CHANGE BULLETIN 01

F.G.A. No. 21003

ROOMS TO GO – OFFICE RENOVATION & EXPANSION

January 20, 2022

SHEET NUMBER
A2.10A

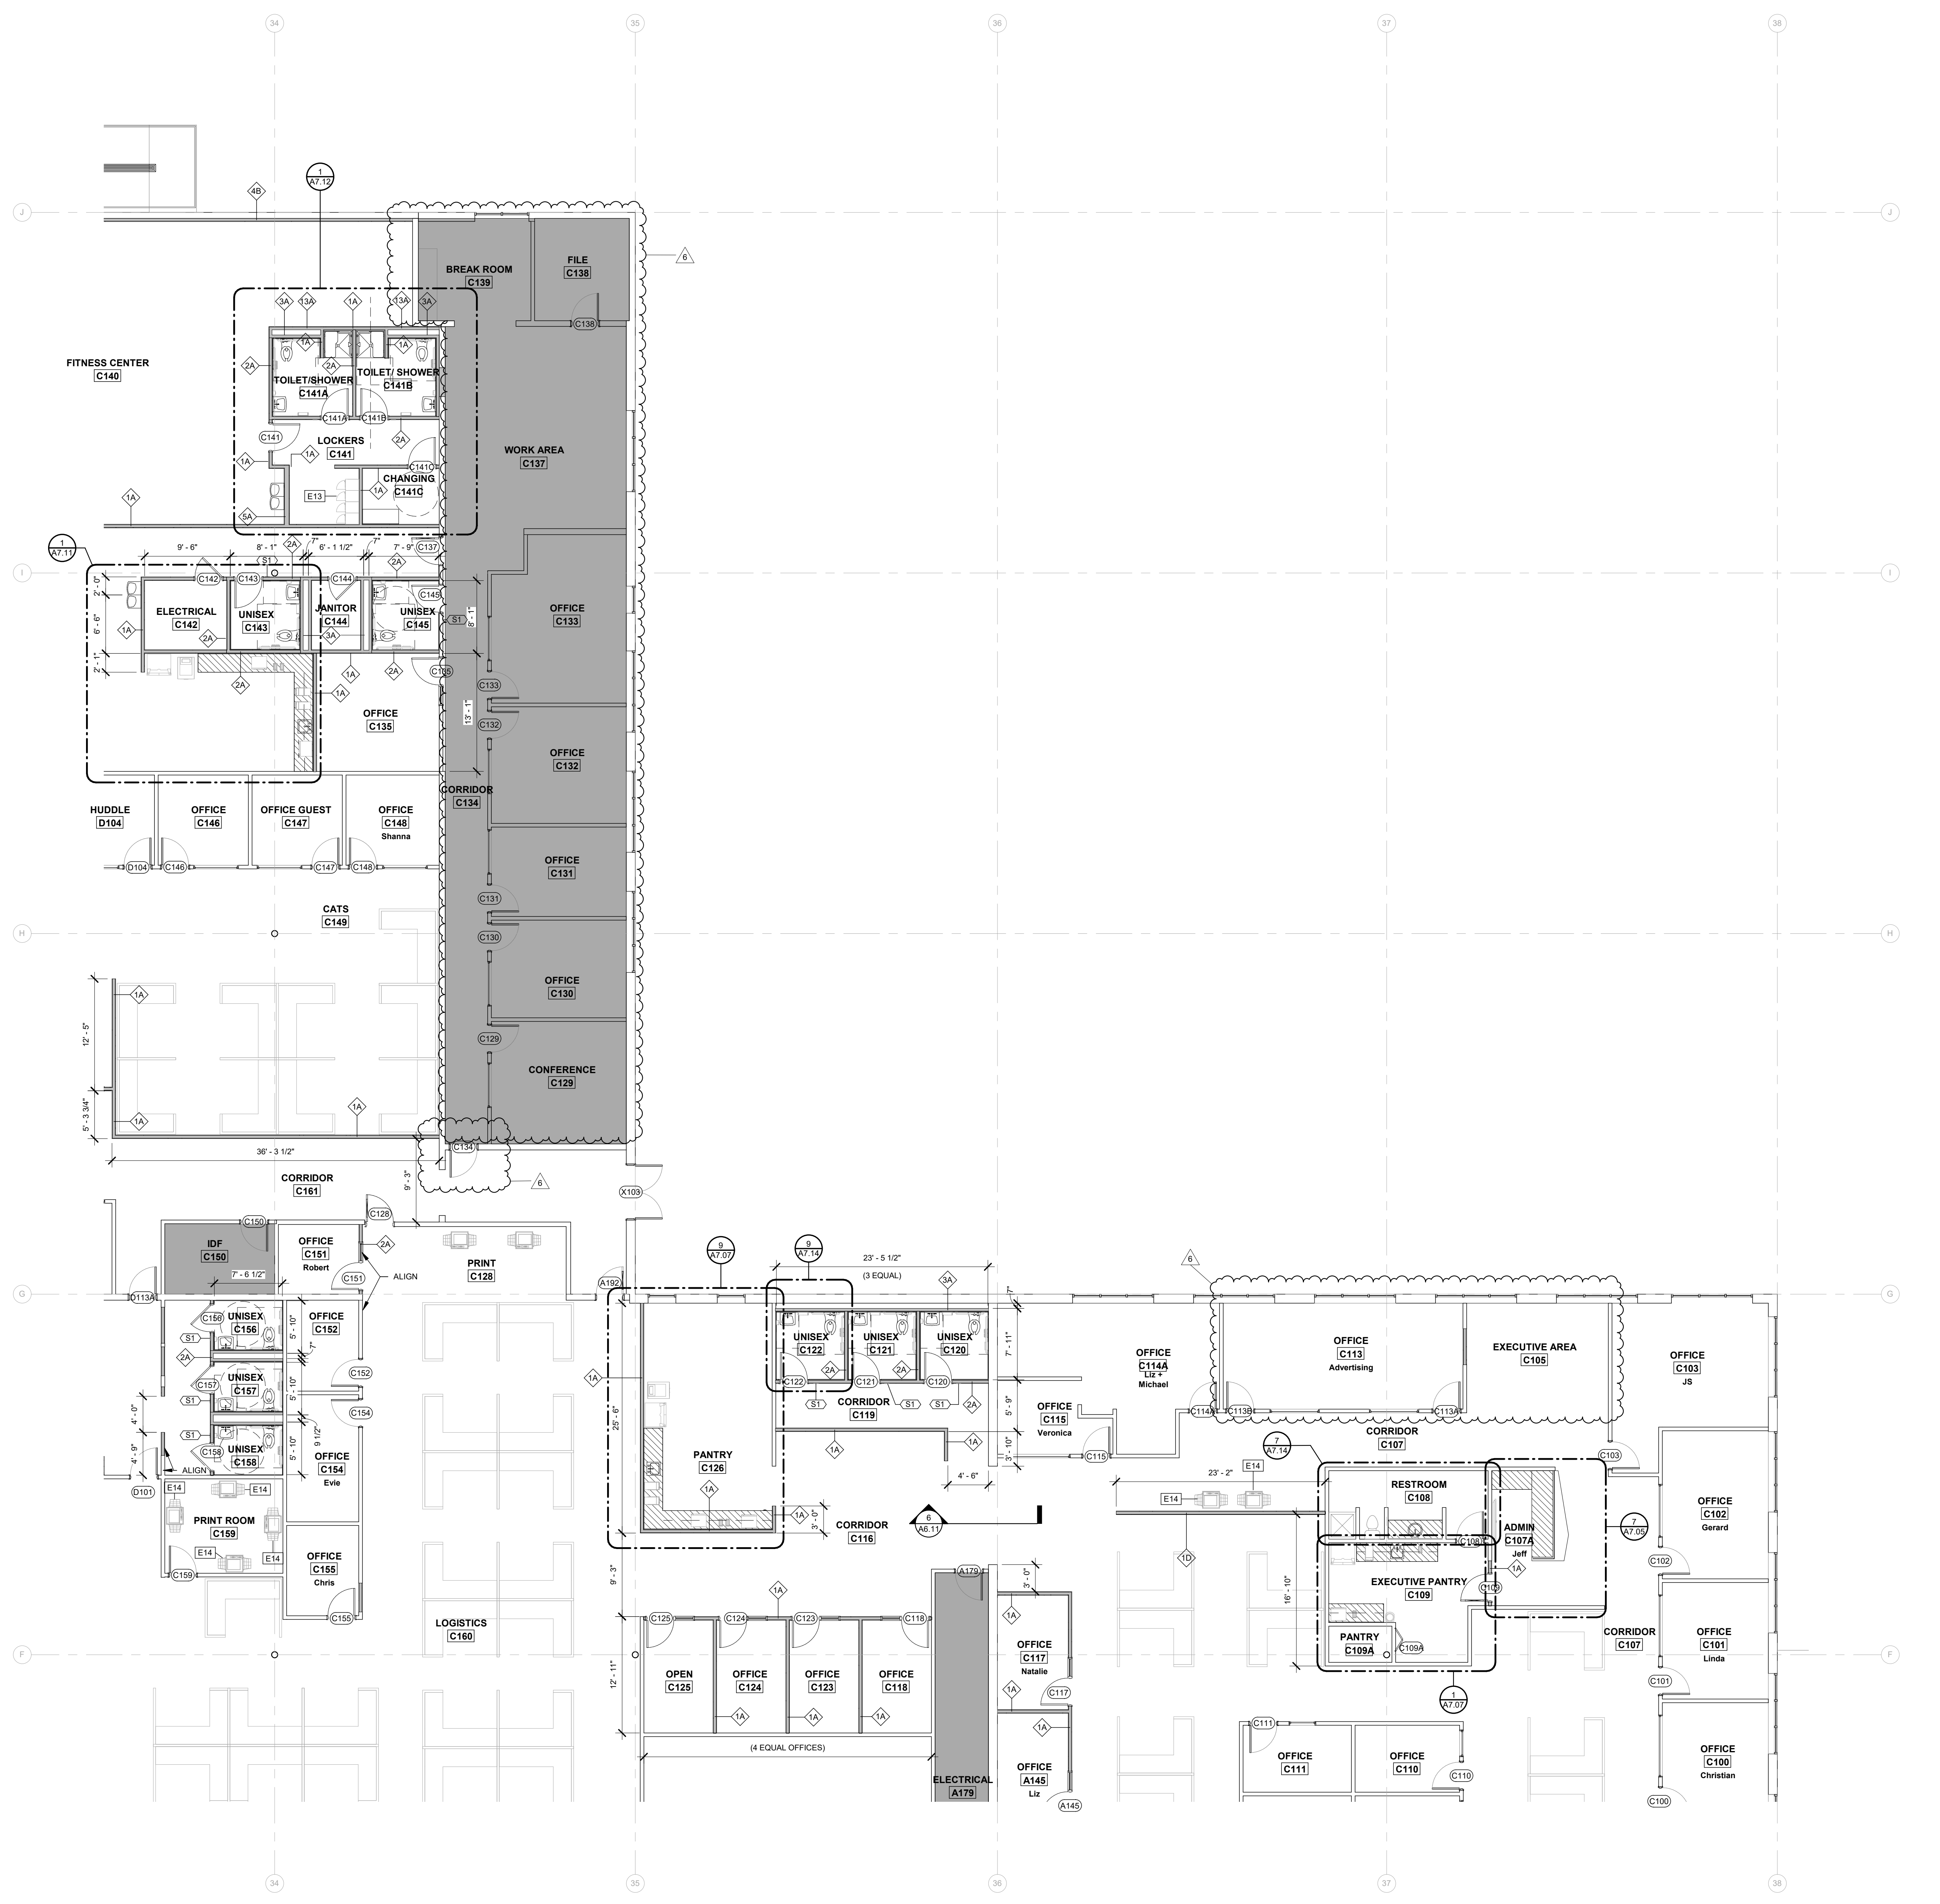
- Item 6: Refer to Sheet A2.10A – Construction Plan A
ADD new sliding door A102
- Item 7: Refer to Sheet A2.10C – Construction Plan C
REVERSE door swing of existing door C134. REMOVE “Jan Area” from scope except for Door C137, Unisex C145 and Office C135. ADD Executive Area C105. REVISE south wall of Office C113 to reflect existing conditions. Doors C113A and C113B are existing doors to remain. Doors C104, C105, C106 and C106A are no longer in the project.

SHEET NUMBER
A3.01

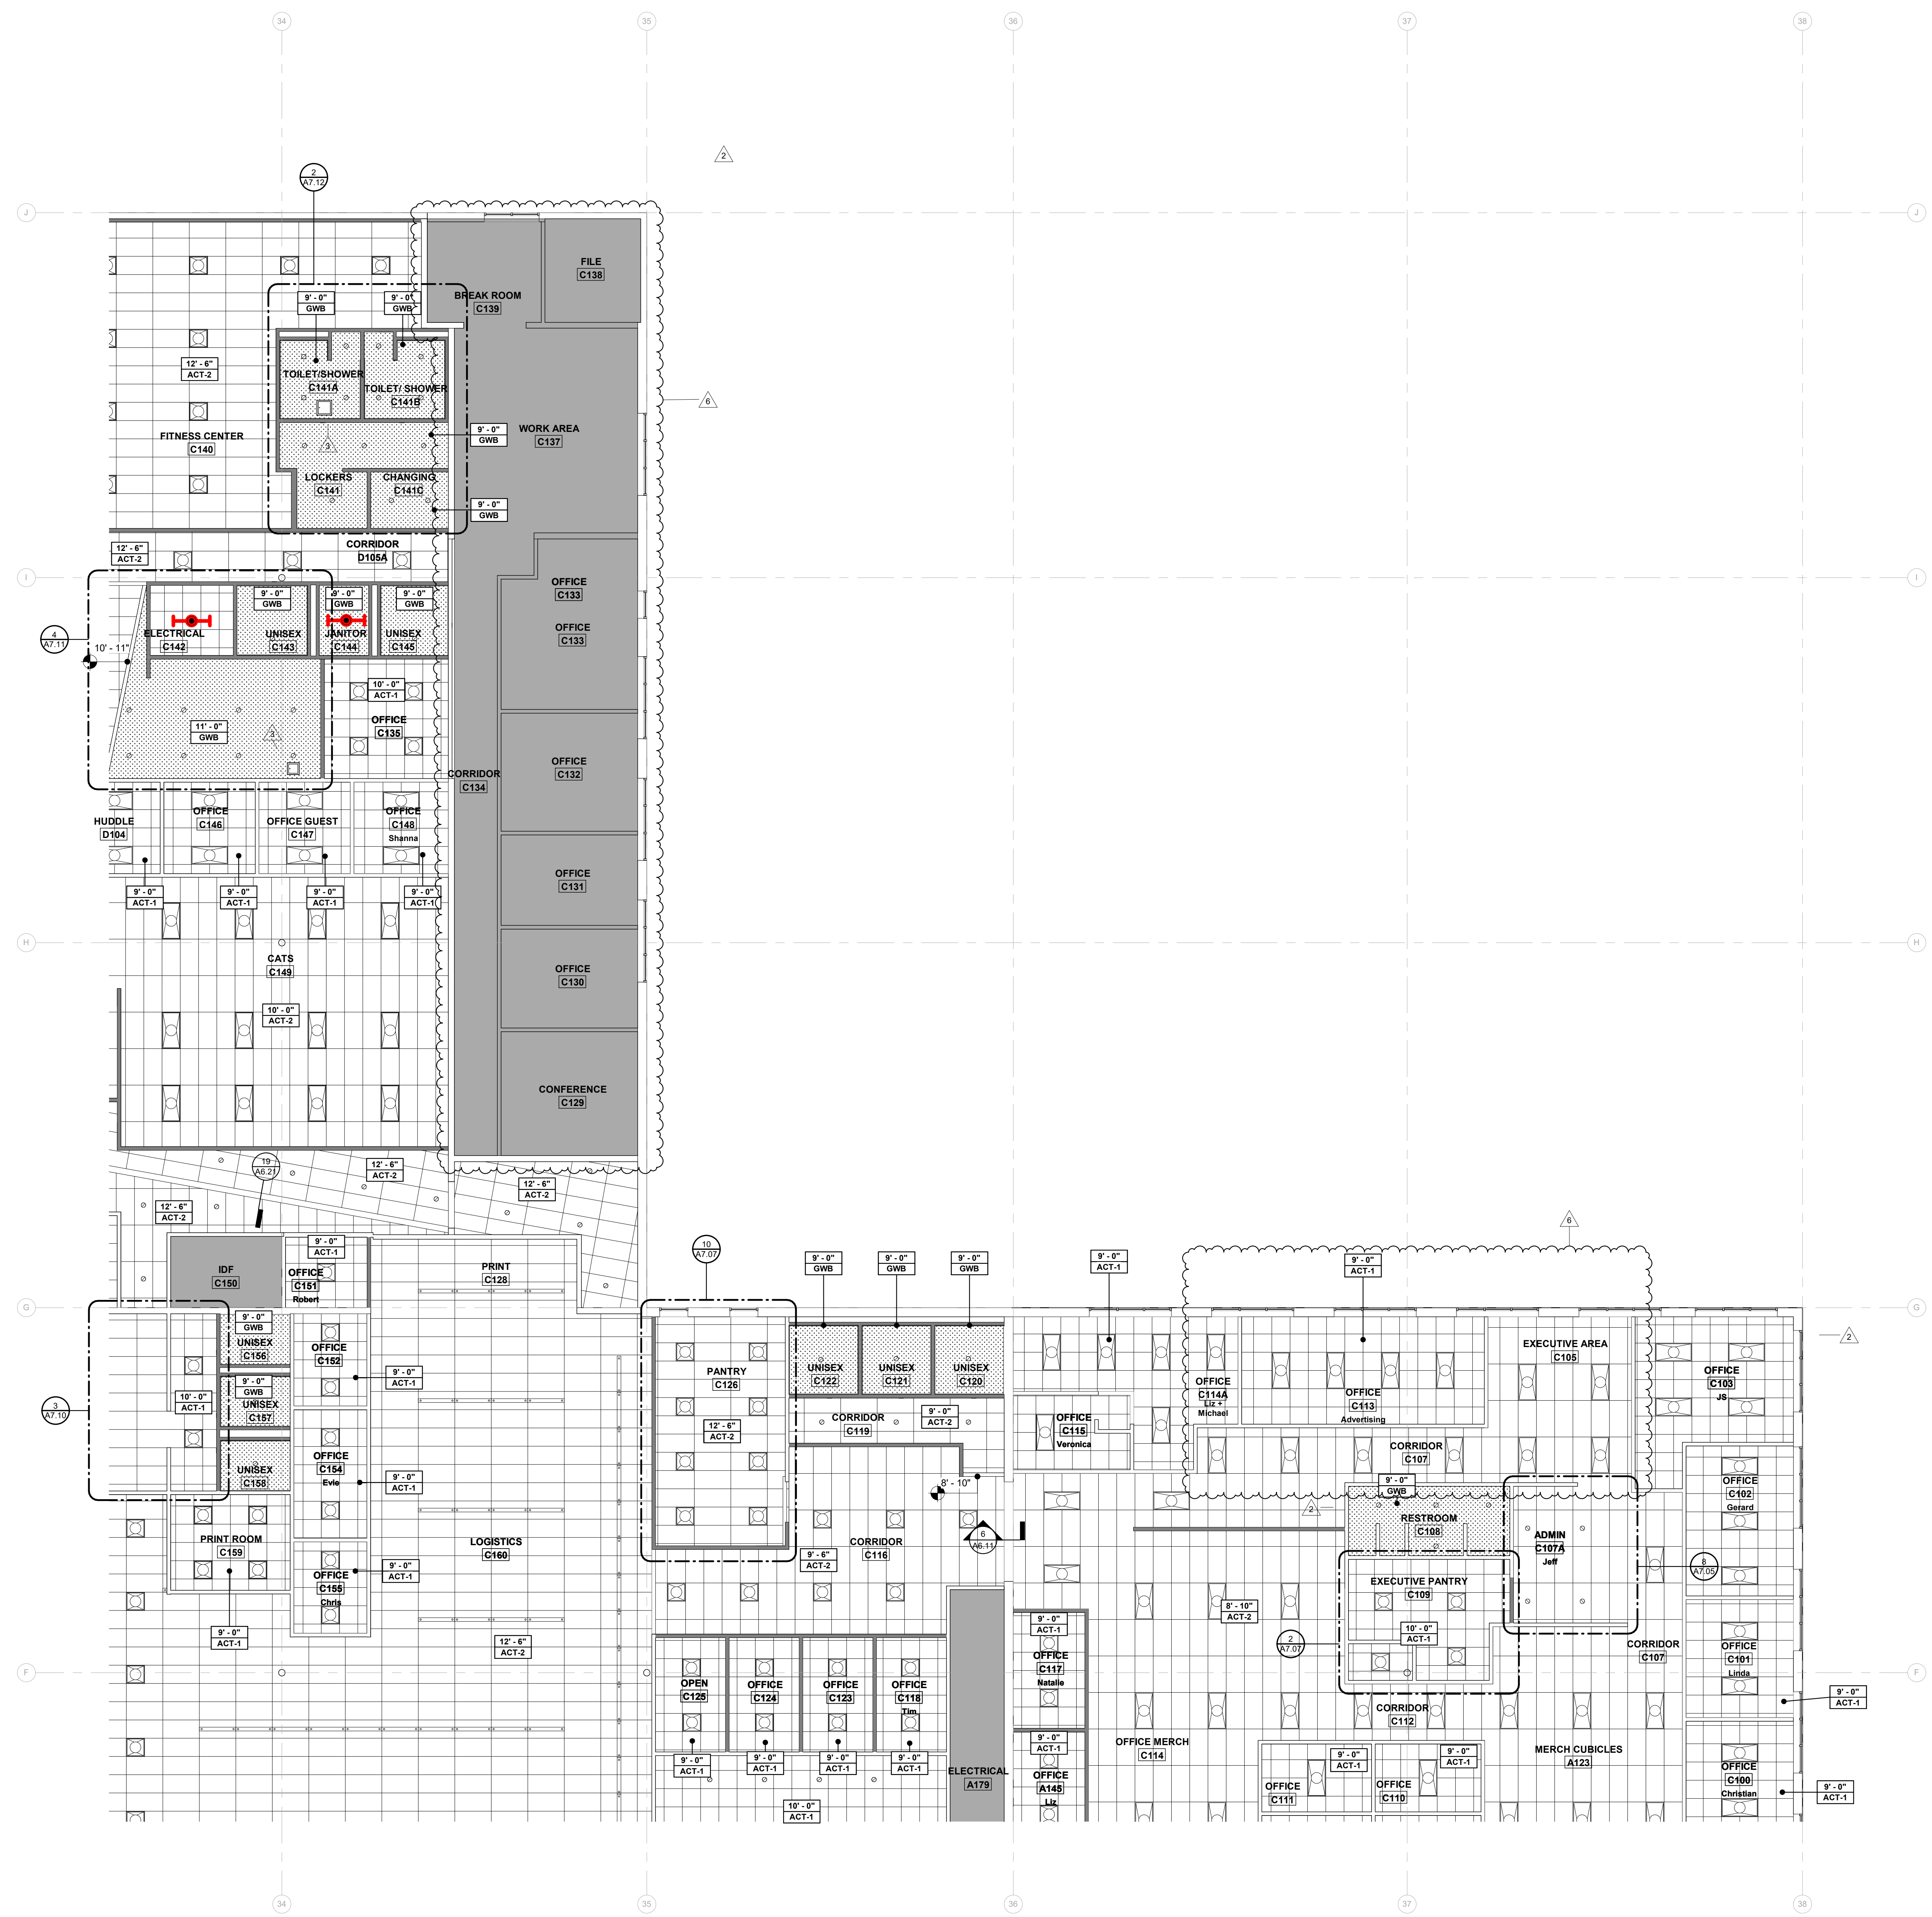
- Item 9: Refer to Sheet A3.01 – Finish Plan Overall
EXTEND carpet into new Executive Area C105. SHOW “Jan Area” as not in scope.
- Item 10: Refer to Sheet A4.01 – Opening Schedule & Details
REVISE door schedule to reflect access control changes and wall repairs. DELETE doors C104, C105, C106 and C106A from schedule.

**SHEET NUMBER
A8.01C**

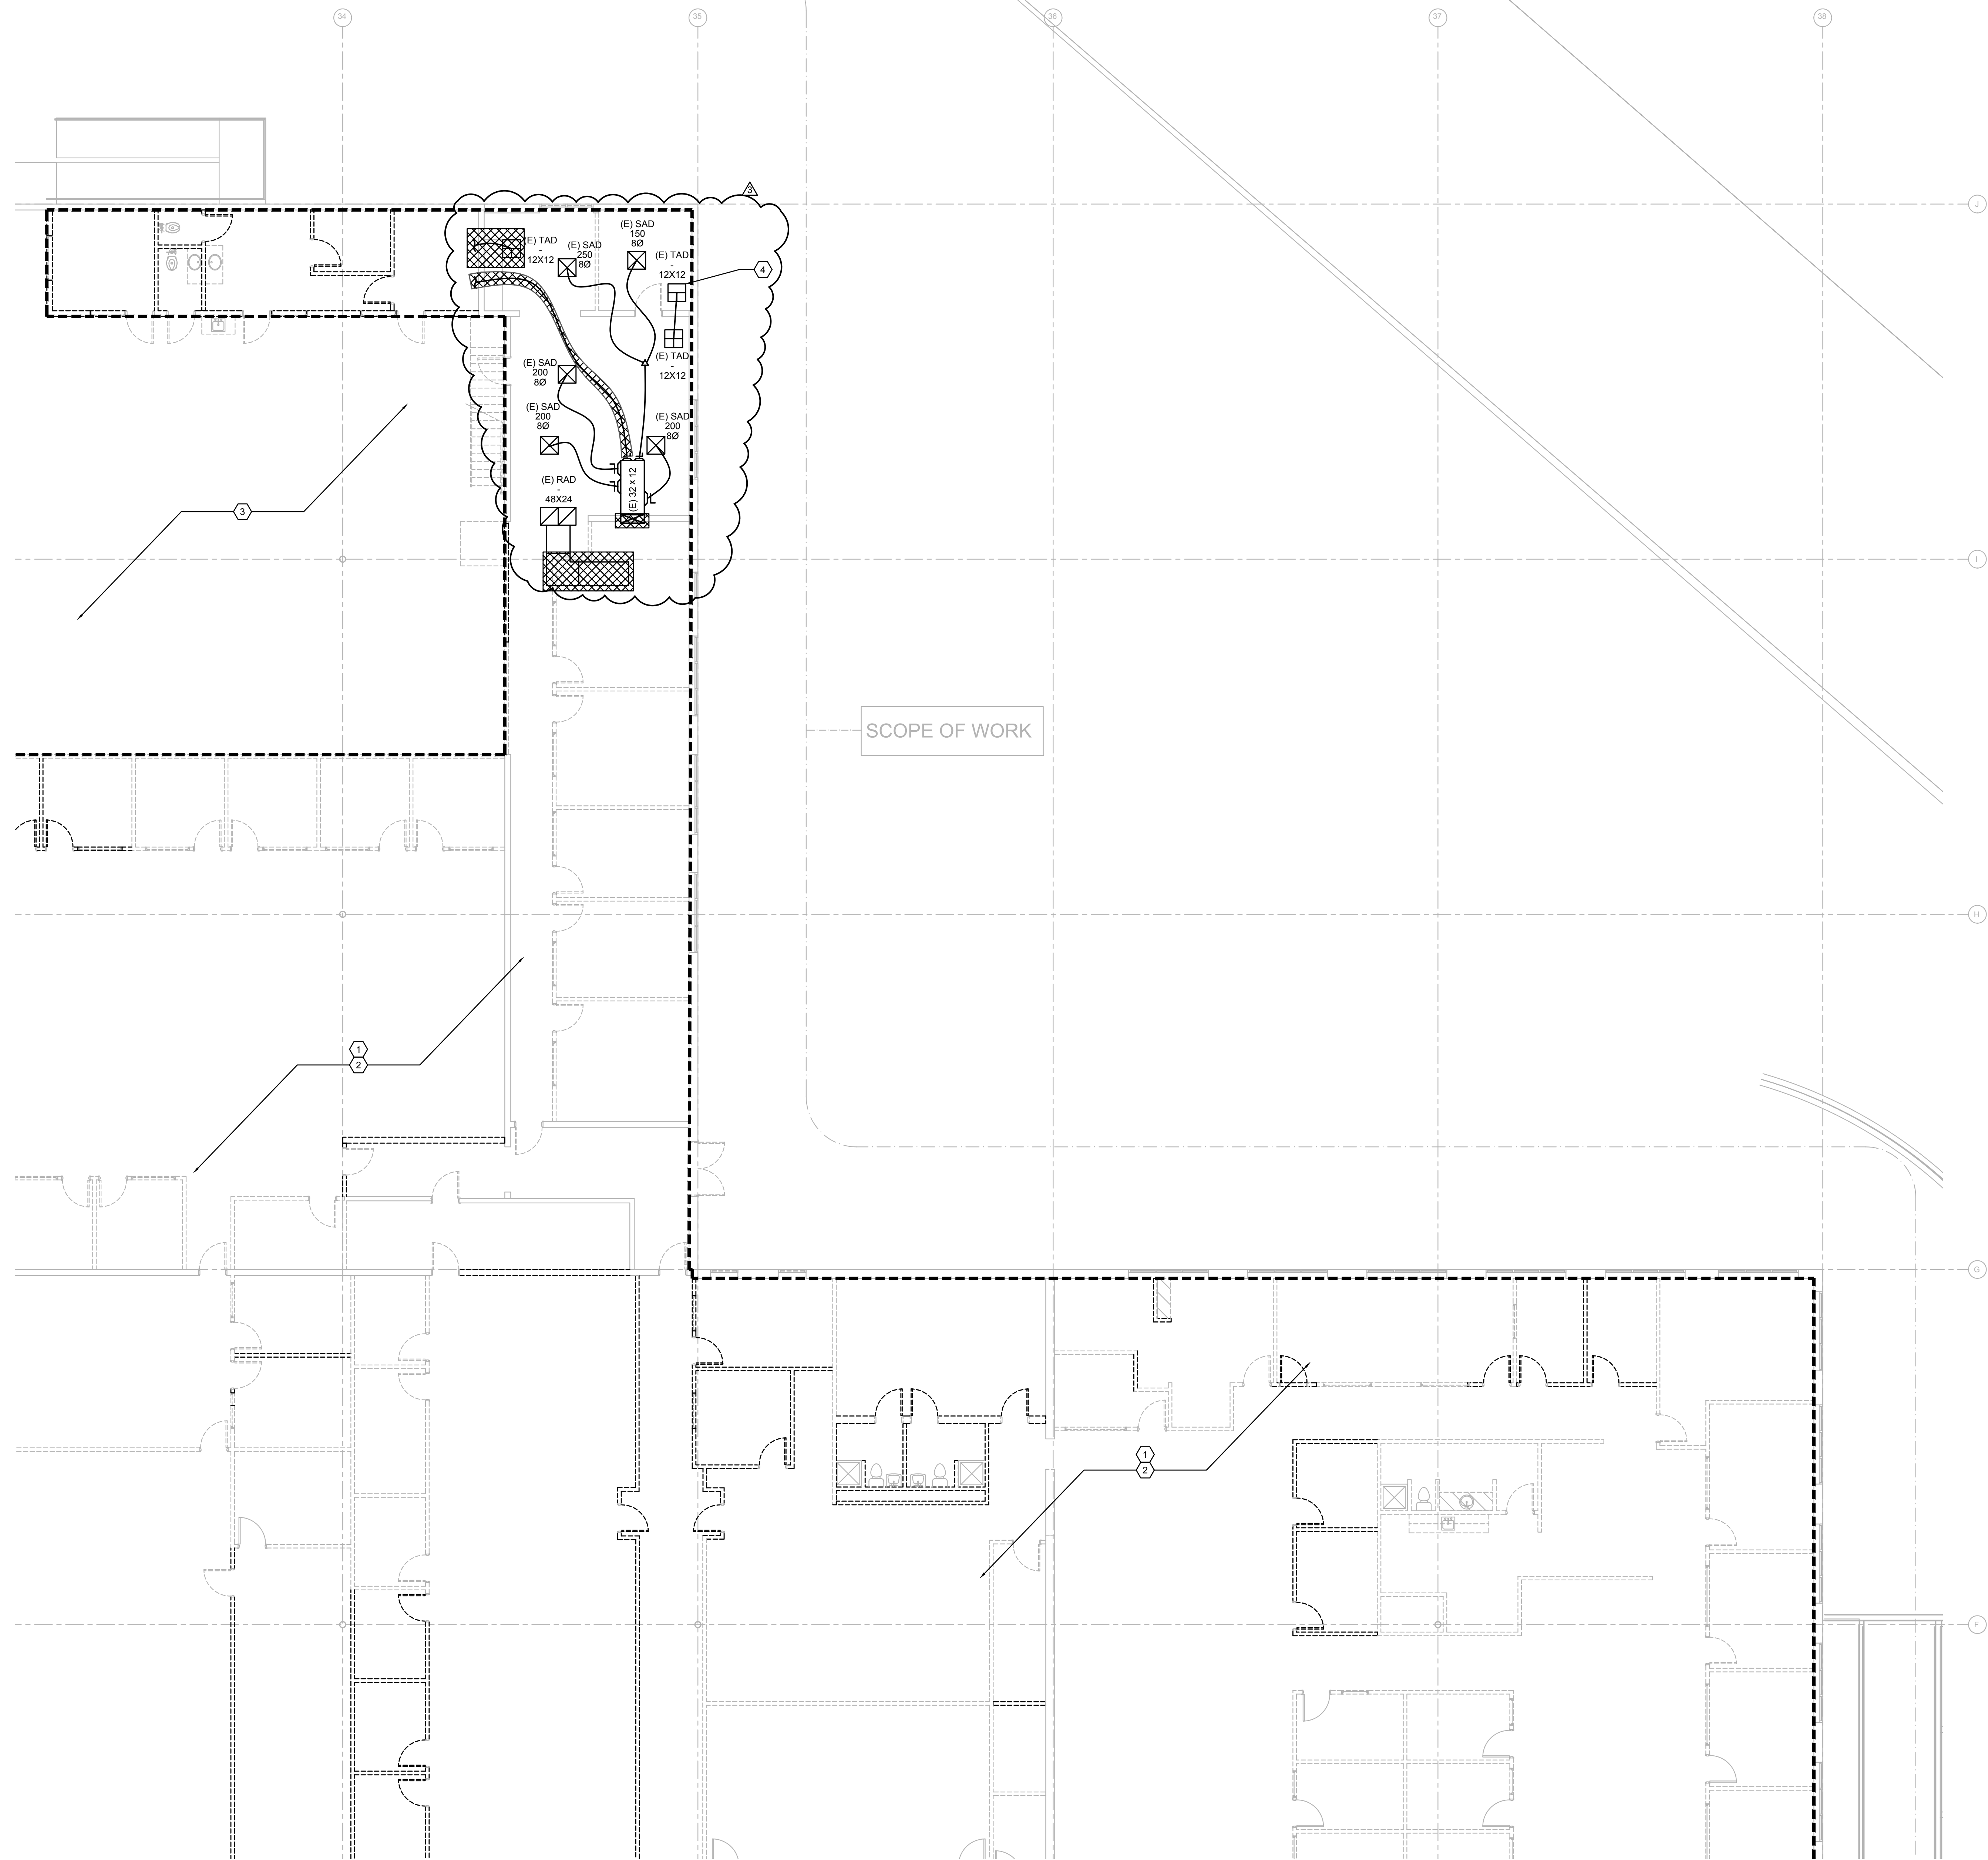
- Item 11: Refer to Sheet A4.02 – Glazing Schedule, Opening Details & Signage
ADD Detail 23 Sliding Door Jamb Detail
- Item 12: Refer to Sheet A8.01C – Reflected Ceiling Plan C
EXTEND Corridor C107 ceiling into new Executive Area C105 and revise lighting. REVISE ceiling and lighting in C113 for the removal of Office C106. REMOVE track lighting and recessed lights in C113. REMOVE all new ceilings and lighting in “Jan Area” and show as “Not in Scope.”
